Metal detection only

QUICK REF. TEMP. ALTERATION : SET UNIT XQ-T2 - UNIVERSAL | art no. 8018464

DOC. ARTICLE NO: 5277922

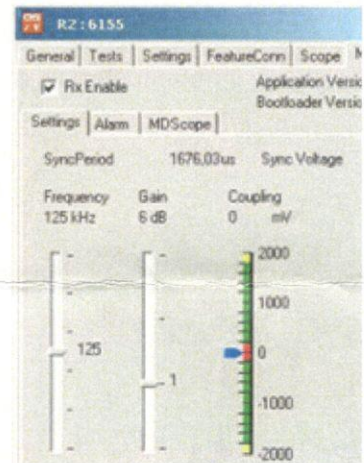
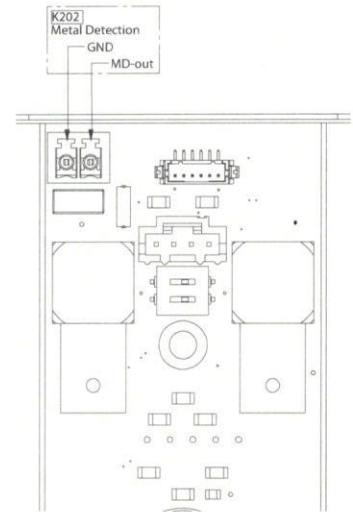
Due to a temporarily problem with availability of a component the connector K202 is mounted 180 degrees turned.

Due to this turning of the connector (K202), the field of the metal detection is also 180 degrees fase shifted.

This is only an issue when you have a MD-transmitter on both sides of a MD-receiver and the field of the both MD-transmitters is in counter fase.

The solution is to change the fase with changing the position of the MD connection on the 50-ohm board.

8.2.7 COUPLING

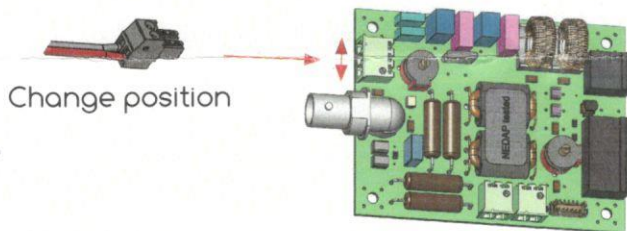
This might be an issue during the adjustment of the system. During this adjustment you have to check the coupling of the metal detection. This must be between the 200 and 2000 mV (see picture).

Coupling in green area.

The measured direct coupling at the receiver Mixer (Vtop). The direct coupling has to be 200mV minimal. When the coupling is less than 200mV the Phase correction integrator does not function properly. The receiver will be blocked by the software and generate no alarms.
